## DEPARTMENT OF PLANNING AND ZONING PLANNER'S REPORT

DATE: August 14, 2019  
 TO: Tonya Hutson  
 FROM: Lynn Patterson  
 RE: **Design Review – 3429 Rainey Avenue Remodel**

The City of Hapeville has received a design review application from Andy Steele to renovate an existing one-story single-family dwelling located at 3429 Rainey Avenue. The renovations would add a second story extending above a new screened in porch on the north side of the house. The final proposed floor area has not been provided. The finished height of the dwelling will be 32'. The property is zoned R-SF, Residential Single-Family, and is subject to the Neighborhood Conservation Area of the Architectural Design Standards.

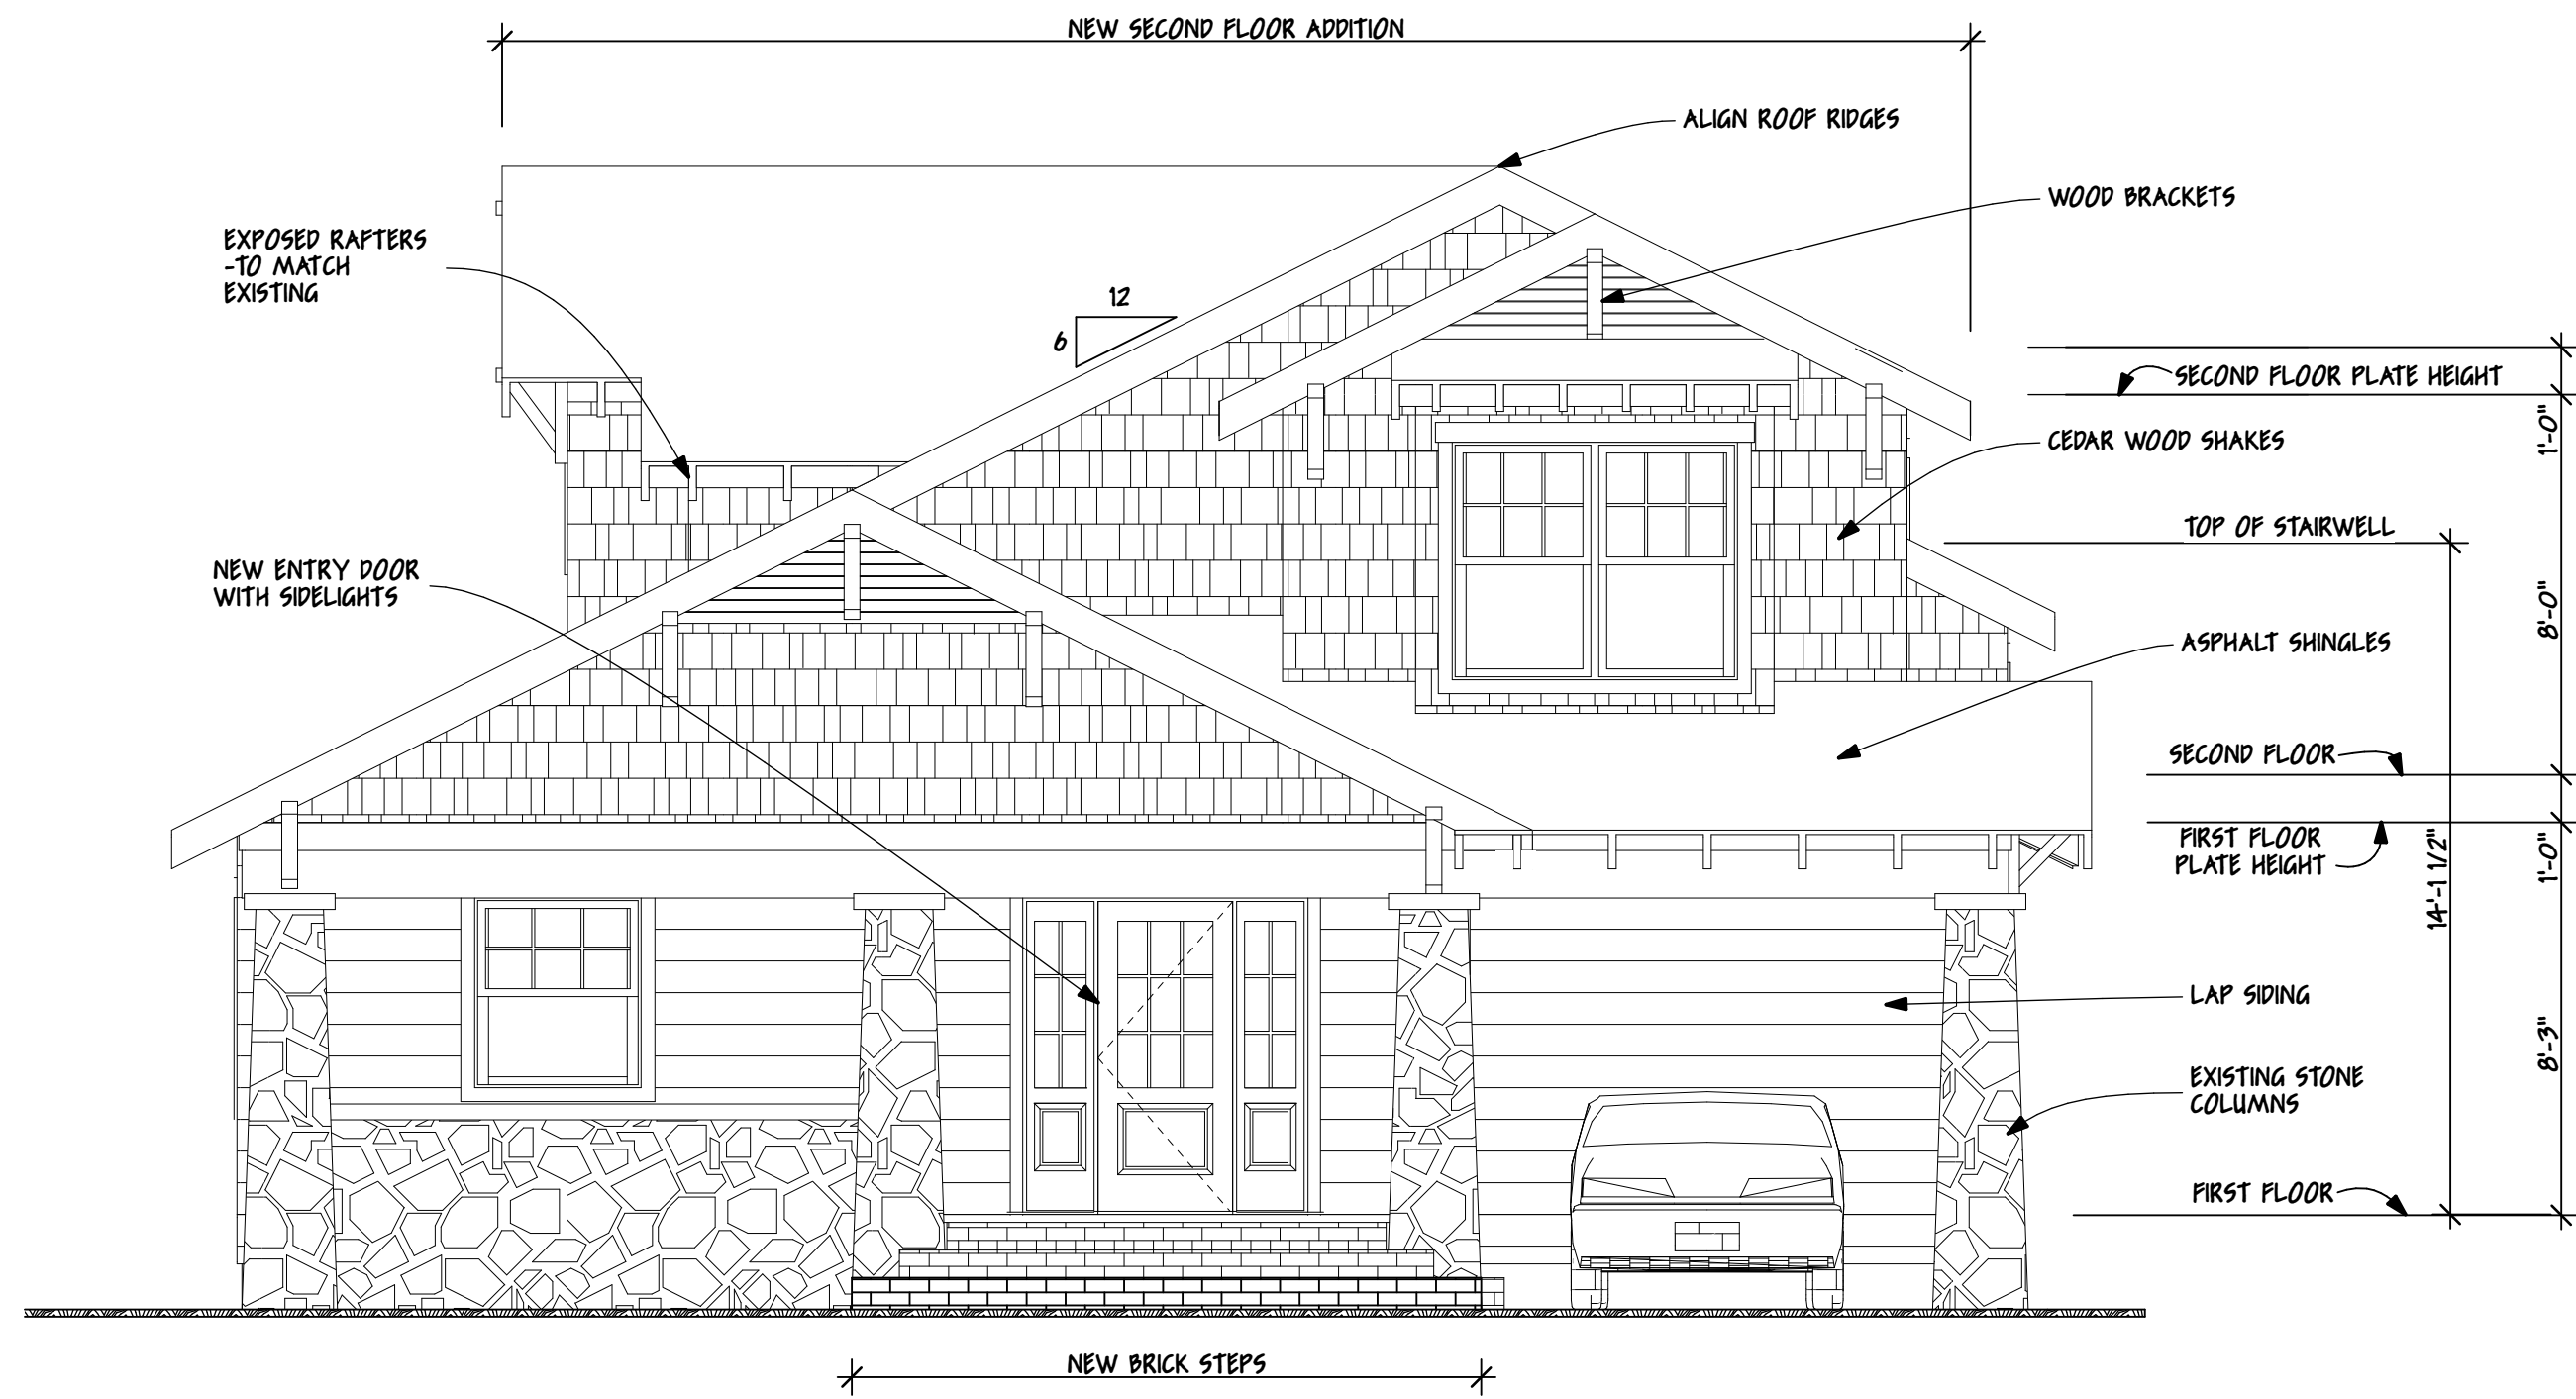
- Existing property is set back 3' from the northern property line, which does not conform with the 5' side setback requirement of the R-SF zone. The applicant has applied for a variance to allow construction within 5' of the property line.

- The width of the existing driveway has not been provided.
- The existing non-conforming carport will remain and will be integrated into the new development.
- Parking is prohibited in the supplemental area, including on a paved driveway. Per zoning, R-SF requires two off-street parking spaces per dwelling. The new construction will remove most of the driveway along the side of the house and reduce the amount of provided off-street parking to approximately one space, which will require a design exception.

1  
A-2 FRONT ELEVATION  
SCALE: 1/4" = 1'-0"

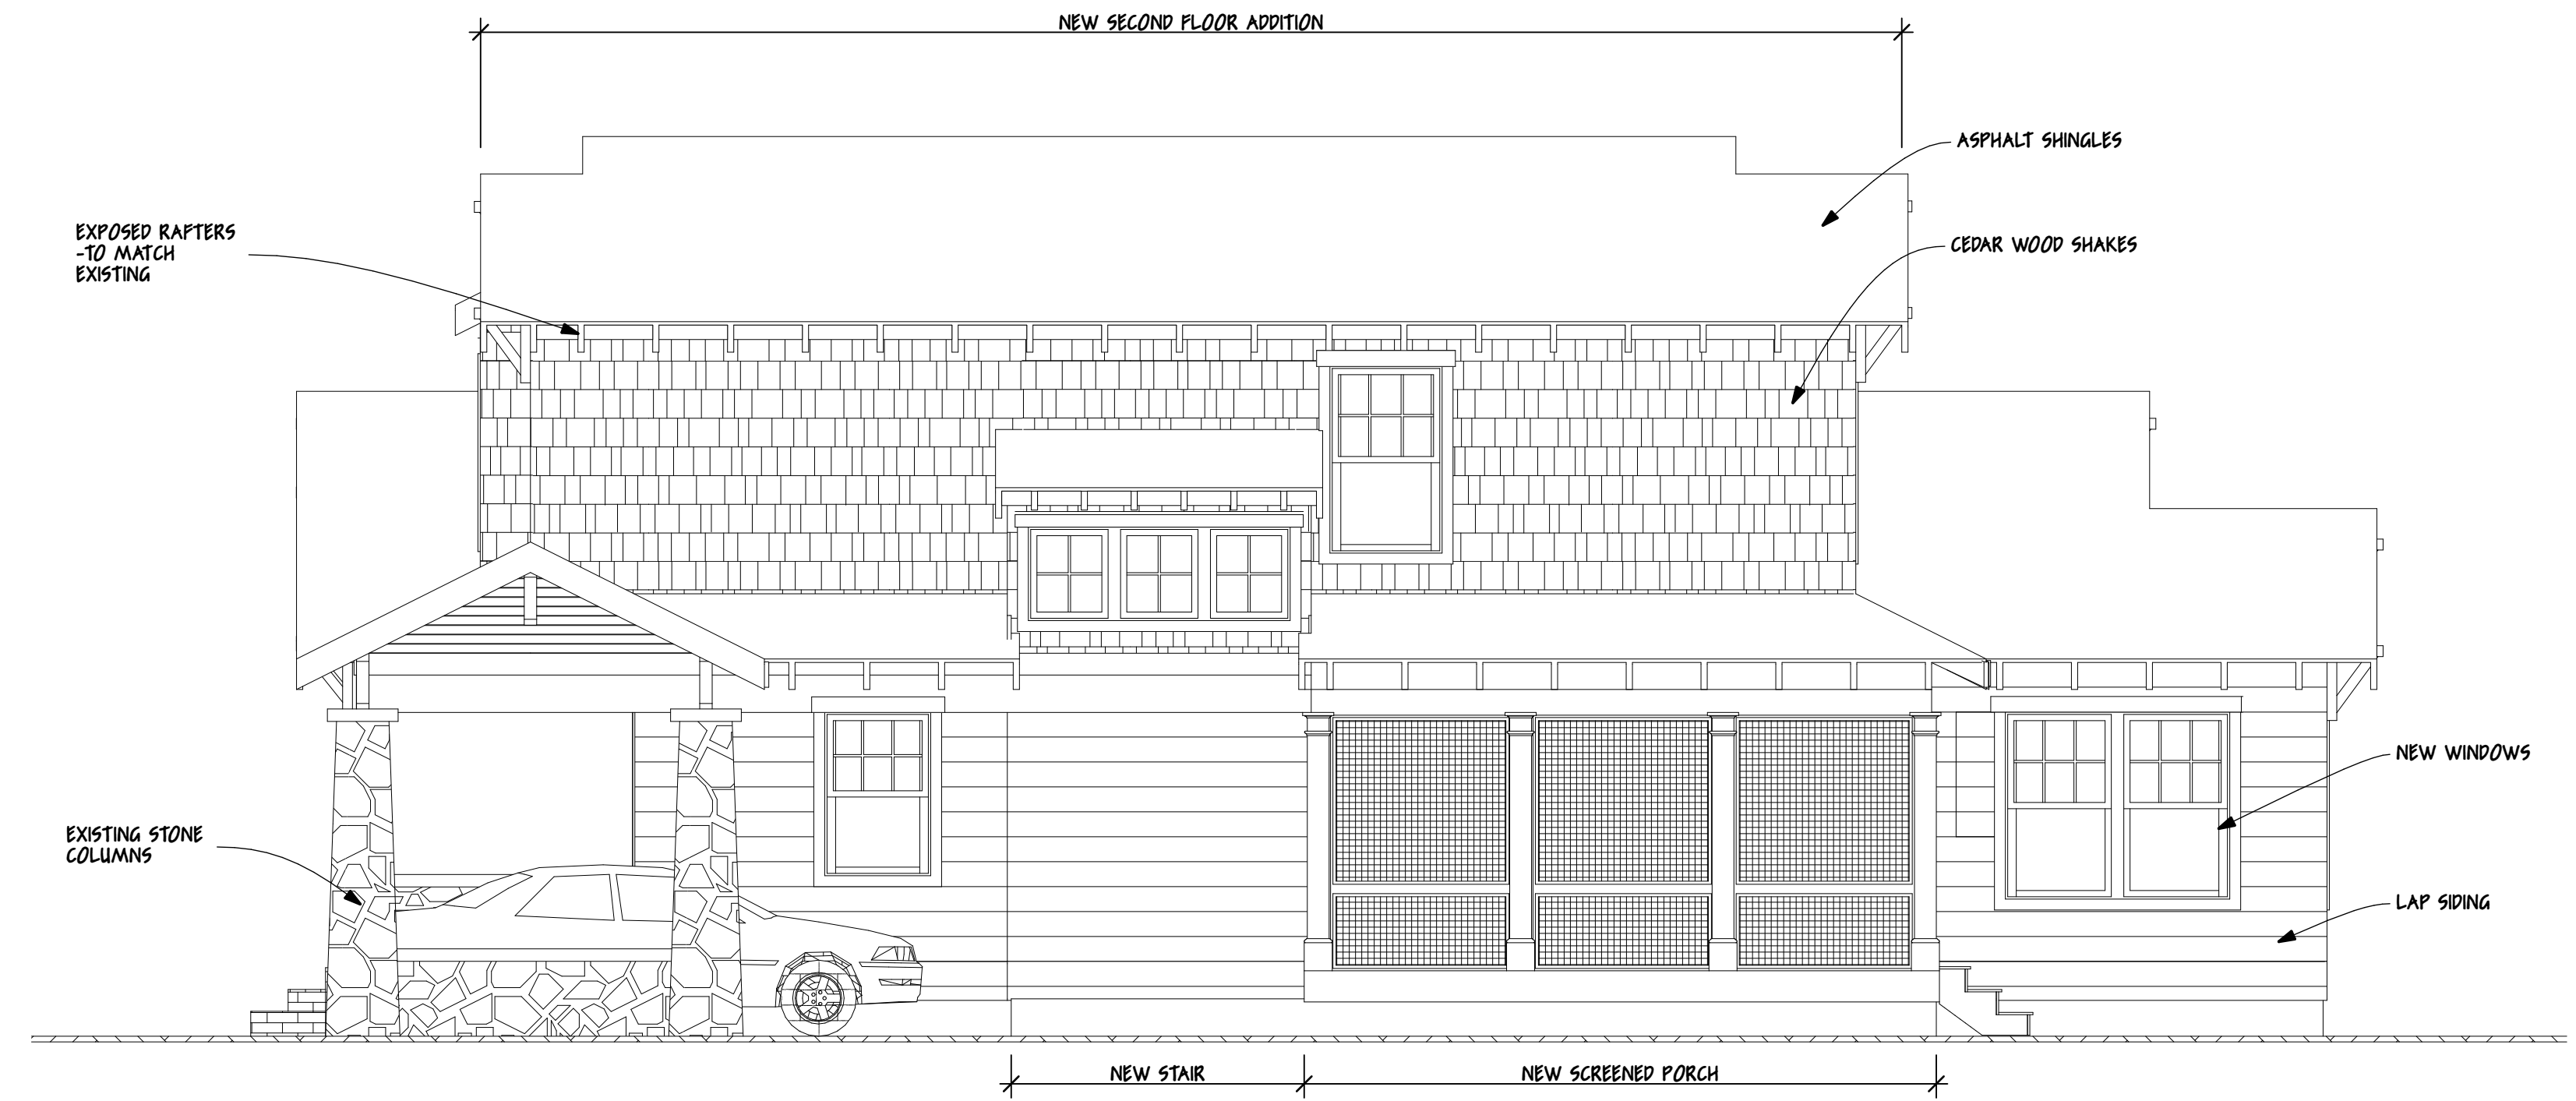
- The Applicant should provide building numbers on the drawings adjacent to the front entrance.
- If used, the Applicant should ensure window lights are not grids-between-glass.
- Necessary information for determining compliance with window standards provided in Sec. 81-1-7(g) has not been provided. The applicant should provide the following for new and existing windows, including those on the door:
  - Window dimensions.
  - Windowpane recession from façade.
  - Window trim material, size, and relief from façade.
  - Width of window mullions between grouped windows.
  - Windowsill materials.
- A window is being removed from the front facade and the proposed addition will

**add a street facing wall without any windows. Windows must be provided for between 30% - 50% of the total street facing facade. The Applicant should provide the width of the street facing facade.**

- e. Windowsill materials.
14. A window is being removed from the front facade and the proposed addition will add a street facing wall without any windows. Windows must be provided for between 30% - 50% of the total street facing facade. The Applicant should provide the width of the street facing facade.
